PROJECT: **Marchmont Road Renewal - Tender**

FILE NO: 2233-02107-00

Addendum #2

Re
Soil Assessment for Marchmont Rd Project, Duncan June 26, 2023
BC

UTILITY PLAN & PROFILE - STA 1+000.00 TO 1+150.00

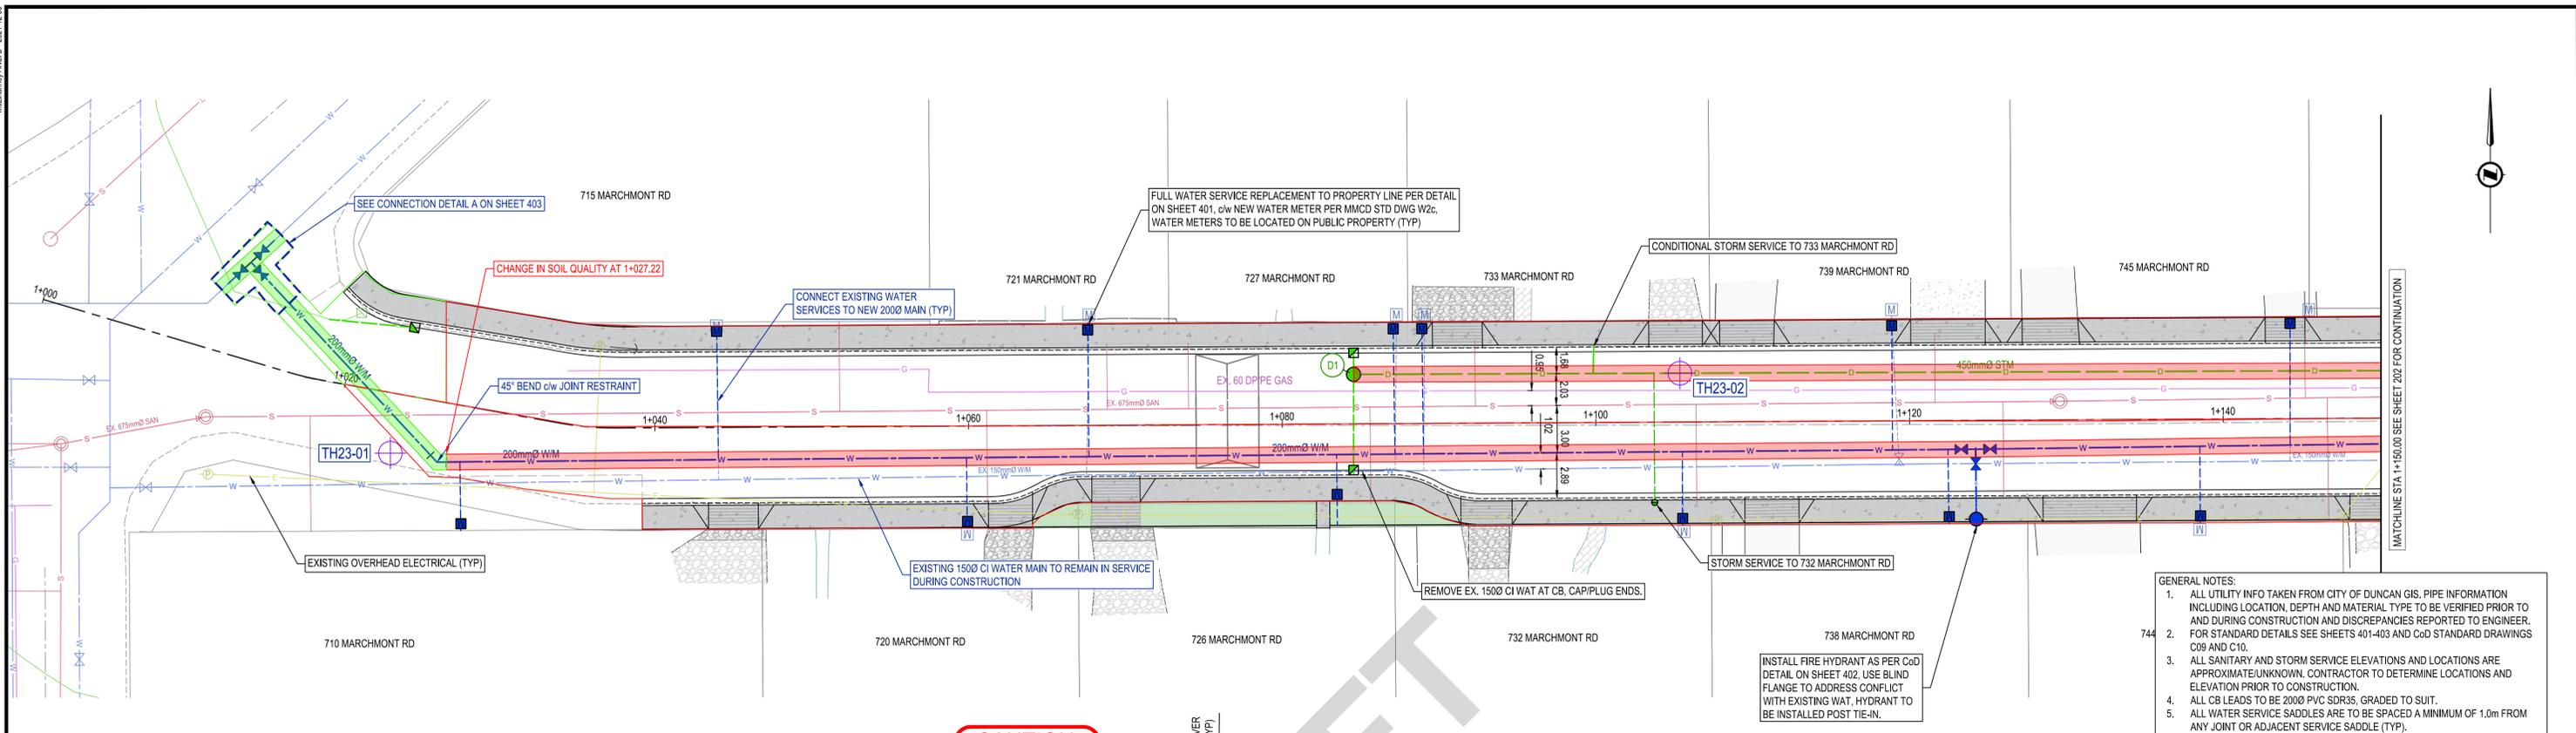
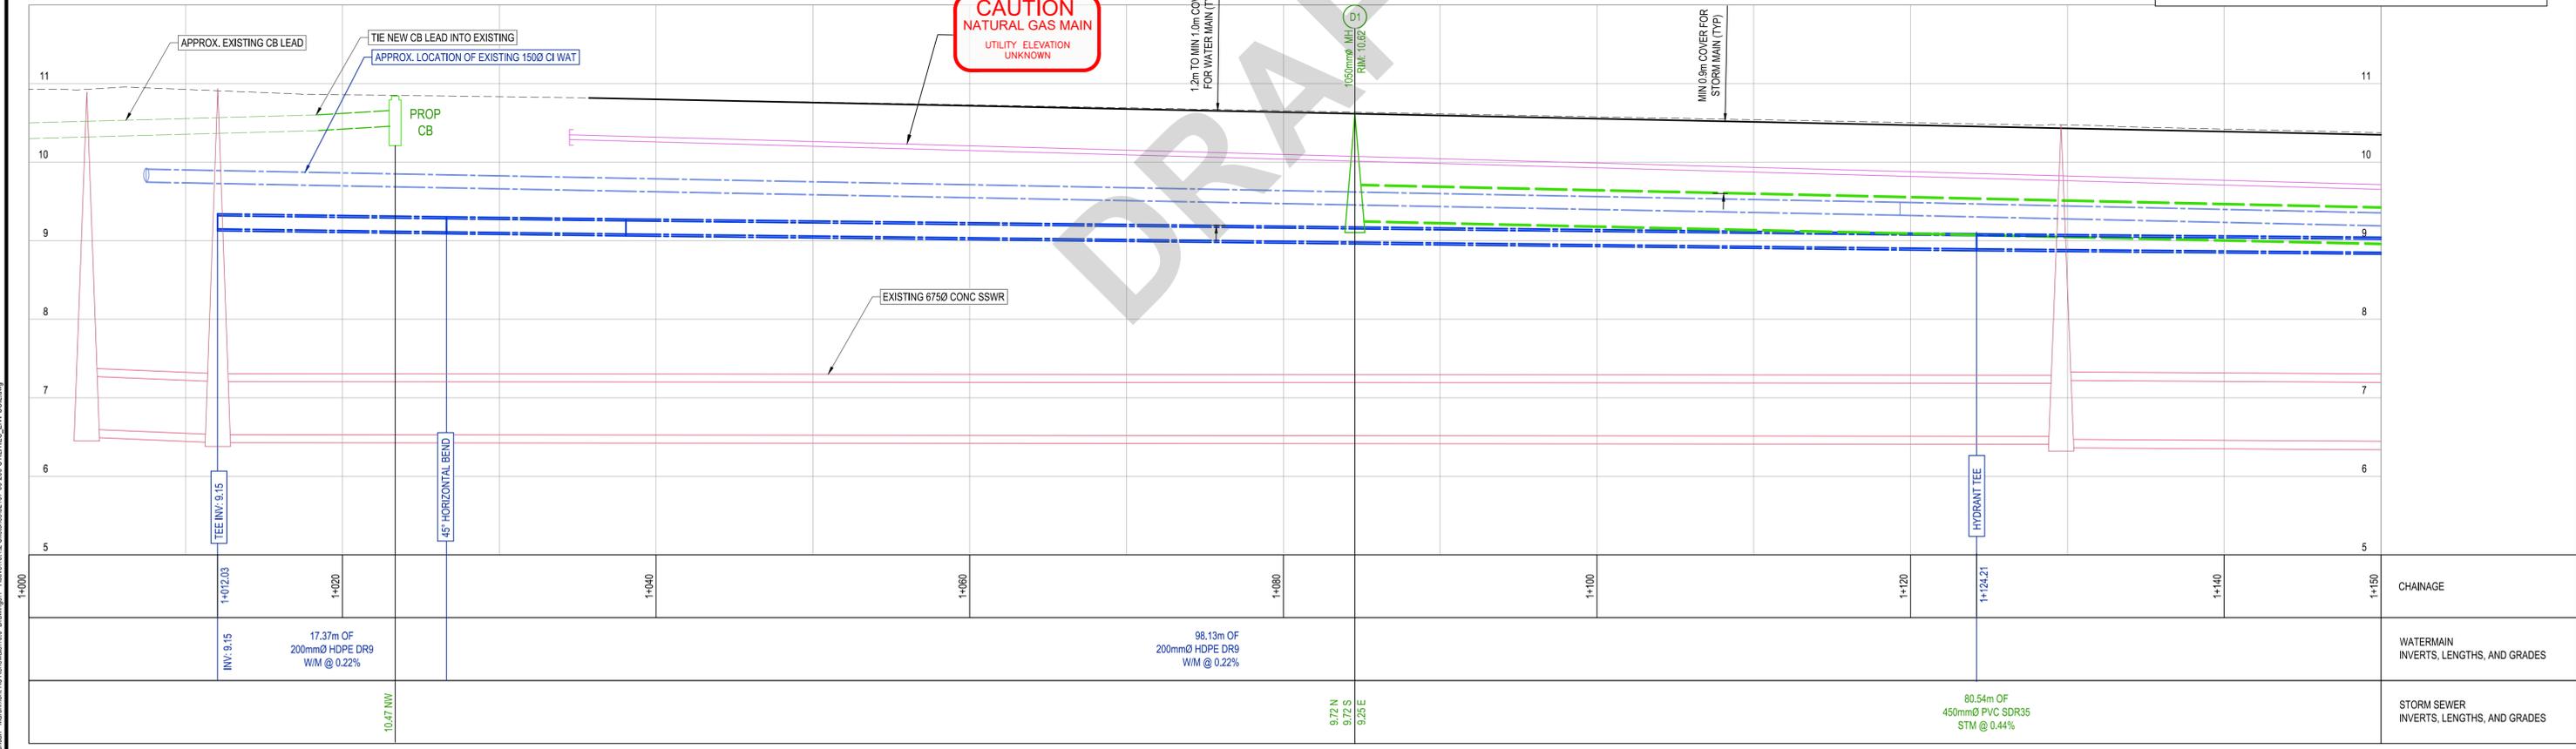
Rev	Date	Description	Drawn	Design	App'd
PB	2023-06-26	ANNOTATION FOR SOIL MANAGEMENT	VA	-	-
PB	2023-05-01	ISSUED FOR TENDER	MR	MR	JL
PA	2023-04-19	ISSUED FOR PERMITTING	MR	MR	JL

Marchmont Rd (westbound lane)	Roadway	IL+	Chloride ions	1+026.5	1+177.92	below asphalt	0.5	981	420
Marchmont Rd (westbound lane) and Day Rd (northbound lane)	Roadway	RLLD-	-	1+177.92	1+255	below asphalt	0.5	504	215
